Access Compliance Report

Public Rights-of-Way

(Curb Ramps)

Intersection ID: N/A	Main Street: STYLE_LN	Cross Street: OUTLETS_BV	Location: SE
ADA ID: 13A6831AA630	Ramp Type: PerpDiag	Initial Pass/Fail: Fail	Overall Compliance: No
Codes/Mitigation Info/Possible Solution		Field Measurements/Component Compliance

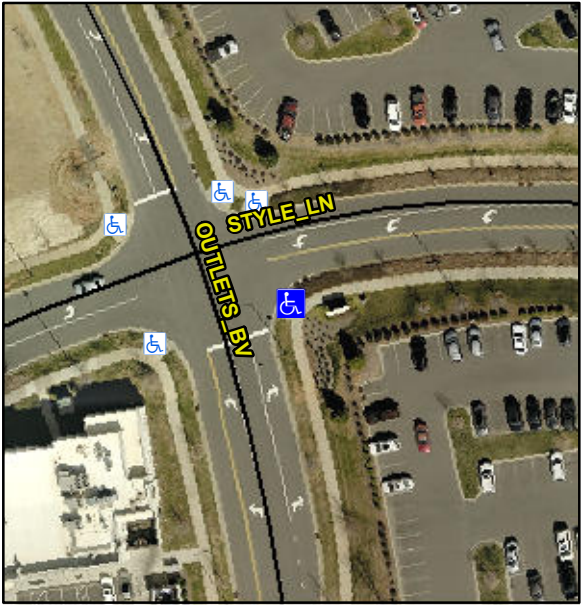
Possible Solutions:	Compliance	Description	Data	Compliance	Description	Data
	Remove & Replace Curb Ramp With Two New Directional Ramps or Equivalent.	N/A	Ramp Length (in)	98.0	No	Ramp Slope (%)	9.1
<p>Surveyor Notes:</p> <p>N/A</p> <p>PROW/ADA:</p> <p>Not Found, R304.2.2, R304.5.3</p>		Yes	Ramp Width (in)	48.0	No	Ramp XSlope (%)	4.1
		N/A	Flare Type LT	N/A	N/A	Flare Type RT	N/A
		N/A	Flare Slope LT (%)	N/A	N/A	Flare Slope RT (%)	N/A
		N/A	Flare Traversable LT?	N/A	N/A	Flare Traversable RT?	N/A
		N/A	Landing Length (in)	N/A	N/A	DWS Provided?	N/A
		N/A	Landing Width (in)	N/A	N/A	DWS Contrast?	N/A
		N/A	Landing Slope (%)	N/A	N/A	DWS Length (in)	N/A
		N/A	Landing X Slope (%)	N/A	N/A	DWS Full Width?	N/A
		N/A	Landing Curb? (Y/N)	N/A	N/A	DWS Offset (in)	N/A
		N/A	Shared Landing?	N/A			
		N/A	Gutter Ponding?	N/A	N/A	Gutter Slope (%)	N/A
		N/A	Gutter Lip Ht (in)	N/A	N/A	Gutter X Slope (%)	N/A
		N/A	Painted X Walk1?	No	N/A	Painted X Walk2?	No

X Walk 1 Direction	To N		X Walk 2 Direction	To W
		N/A	X Walk 1 Width (in)	N/A	N/A	X Walk 2 Width (in)	N/A
			X Walk 1 Slope (%)	1.6		X Walk 2 Slope (%)	2.5
			X Walk 1 X Slope (%)	0.9		X Walk 2 X Slope (%)	4.1
		N/A	Ramp inside XWalk1?	N/A	N/A	Ramp inside XWalk2?	N/A
			Road Slope (%)	0.7	N/A	Clear Space?	N/A
			Road X Slope (%)	1.4	N/A	Clear Space to XWalk (in)	N/A
		N/A	Any Obstructions?	N/A	N/A	Storm Grate/Utility Hazard?	N/A
			Obstruction Type			Storm Grate/Utility Type	
				N/A			N/A
					Yes	Surface Condition? (G/P)	Good
